SERVICE BULLETIN

SERVICE BULLETIN INDEX

FIGURE 3

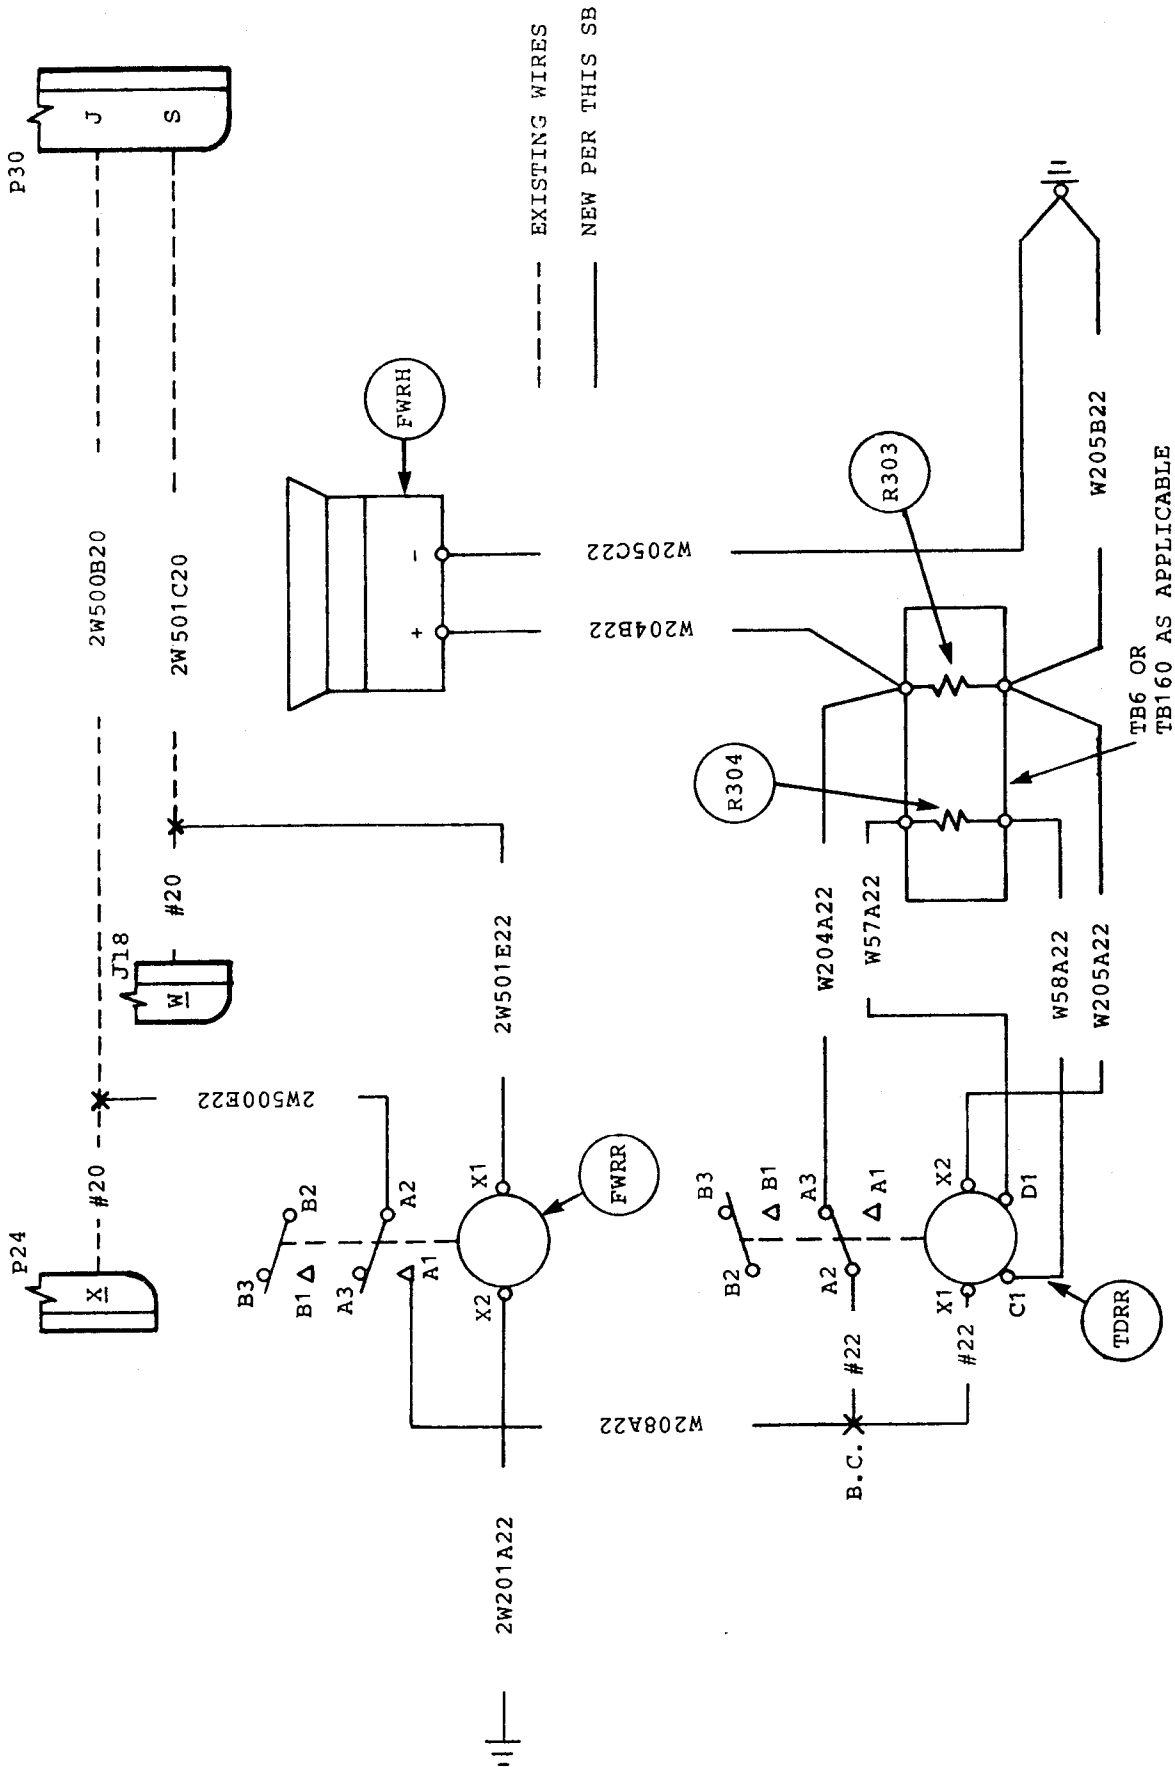
- (1) Complete all wiring as per Figures 2 and 3 (LHS and RHS, respectively), using standard shop practices.
 - (a) Plugs J49 and J18 are located on shelf aft of forward pressure bulkhead.
 - (b) Plugs P23 and P24 are located in the overhead panel (LHS and RHS, respectively).
 - (c) The terminal block is located and identified as per Figure 1 on the instrument panel support.

FIGURE 1
CUTTING OF RUDDER SERVO TRIM TAB
SHEET 1 of 2

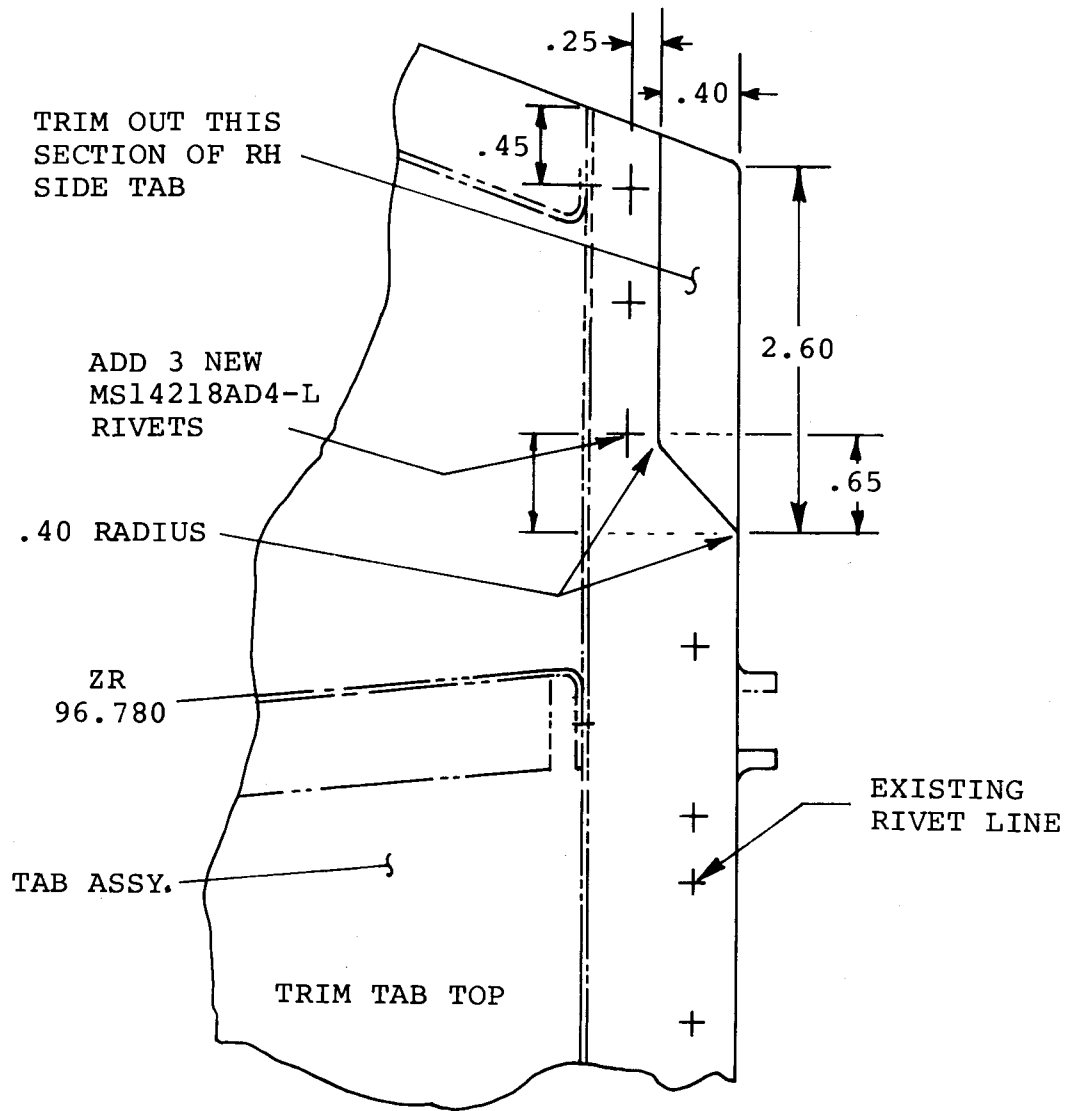
- A. Remove the rudder servo trim tab from the aircraft rudder in accordance with 1124/1124A Maintenance Manual, Chapter 27-20-00, removal/installation paragraph 3A.
- B. Layout area to be trimmed in accordance with Figure 1.
- C. (1) Before trimming off any material observe the proposed outline for rivet edge distance to the spar radius and leading edge. If the edge distance on your rudder tab conforms to the measurements on Figure 1 utilize the rivet pattern reflected in Figure 1 to effect the modification.

Make sure that a minimum of 2D (.25) edge distance from center of rivet hole shall be maintained after cutting out completely the existing 1/8 rivet holes in a straight line as shown in Figure 1.

- (2) If the remaining edge distance results in less than those measurements reflected in Figure 1, go to Figure 2.
- (3) Since edge distance determines rivet size and quantity, it is important that the number of rivets in Figures 1 and 2 be used to maintain integrity of the tab leading edge. Select the rivet pattern that will best suit the required number to accomplish the modification.

FIGURE 1

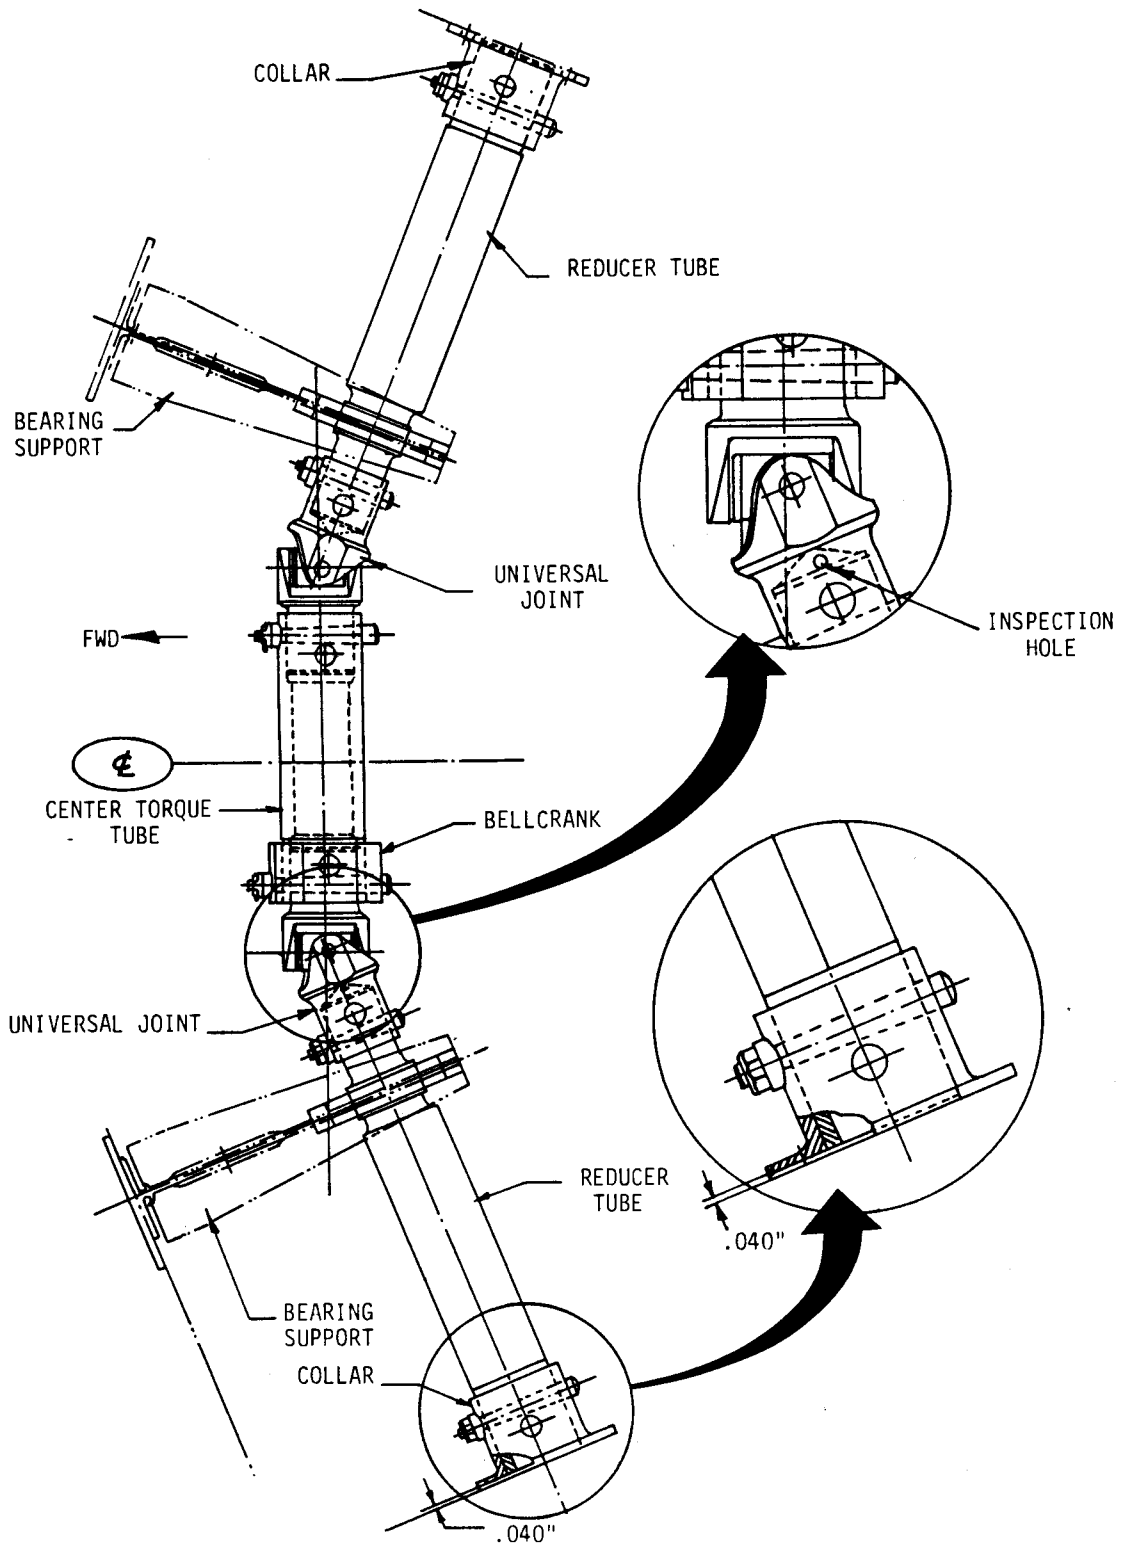
- C. Perform dye-penetrant inspection in radius of both collars (reference Figure 1).
- D. If no defects, proceed to step E. Defective collars must be replaced with a new reducer tube P/N 3533579-501 and collar P/N 3533577-1 as follows:

FIGURE 1

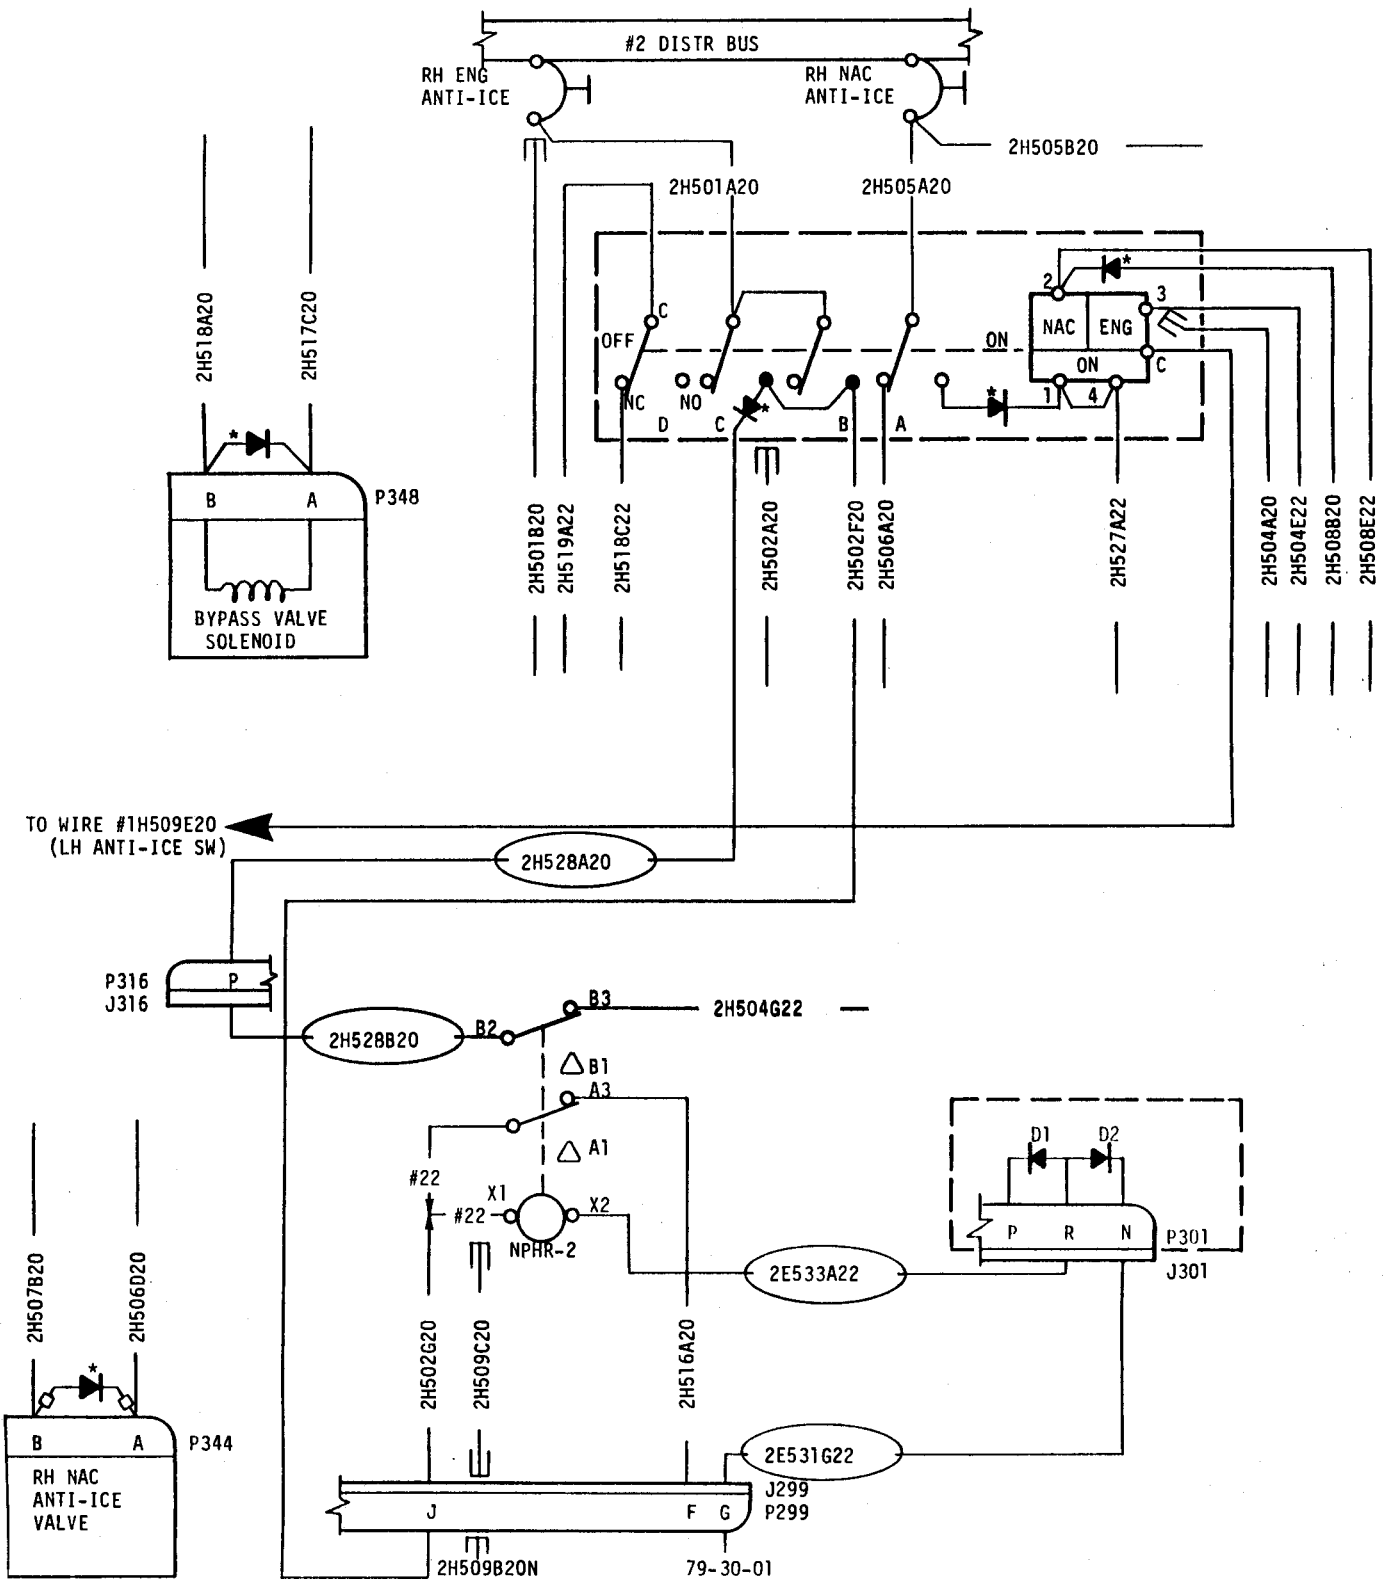
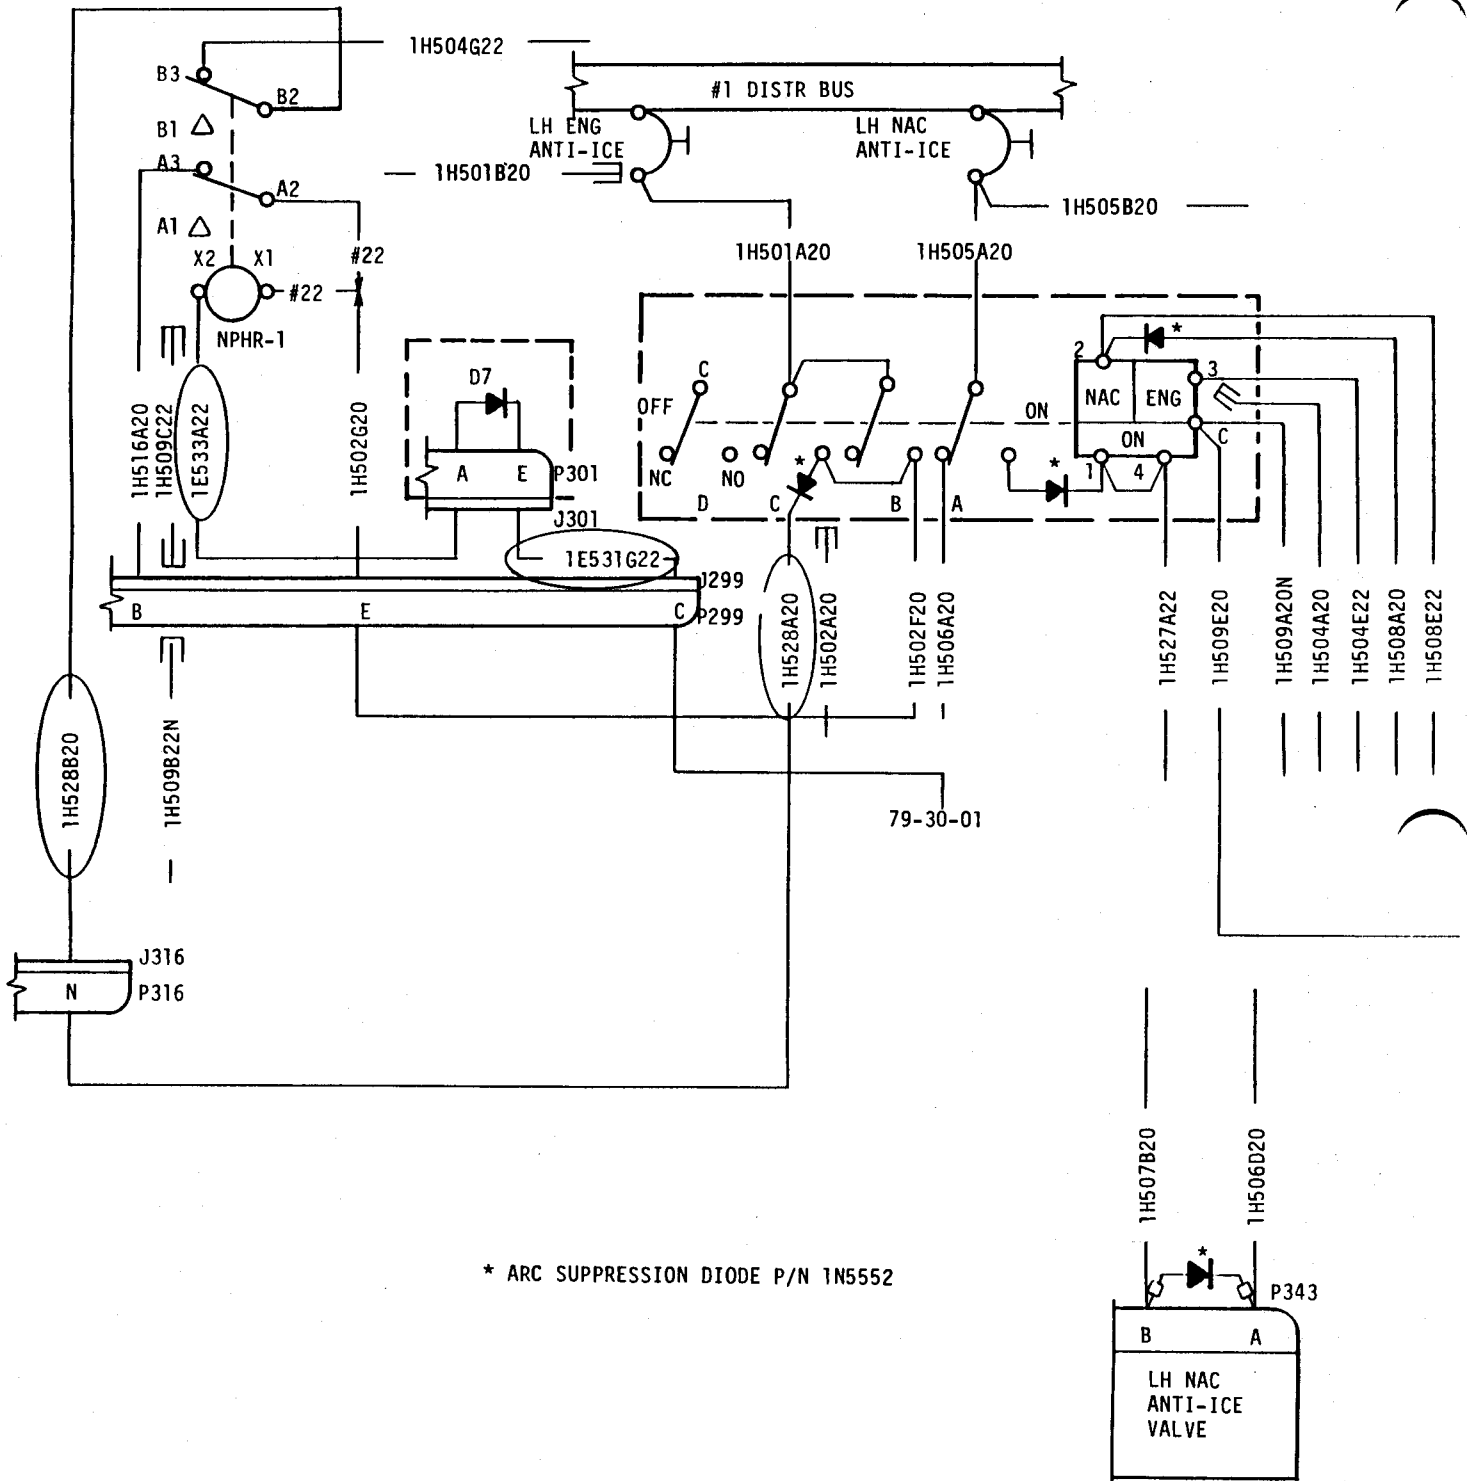
B. Revise your Wiring Diagram Manual Chapter 30-20-01 and 21-00-01 per Figures 1 and 2 of this bulletin to reflect the changes accomplished by this Service Bulletin.
